Key Automation News 06.2018

NEW ACCESSORY FOR ALT424K

ASTL5

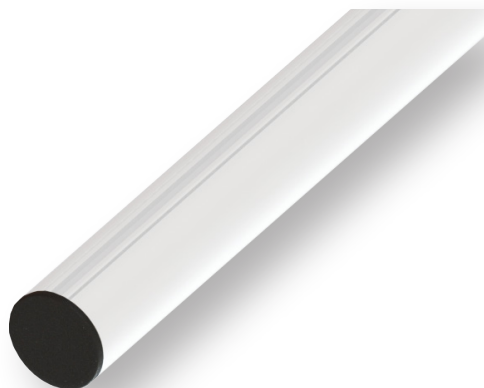
- New ASTL5 aluminium bar, L = 5 m, Ø 60 mm
- Compatible with PROFT6 and KLIGHT6
- NOT compatible with APM and SKIRT
- NOT suitable for highly intensive use (maximum 350 opening/closing cycles per day)
- DO NOT use opening motor speed values higher than level 3 (parameter SFO = 3 of the BASE customisation menu)
- DO NOT use closing motor speed values higher than level 3 (parameter SFC = 3 of the BASE customisation menu)
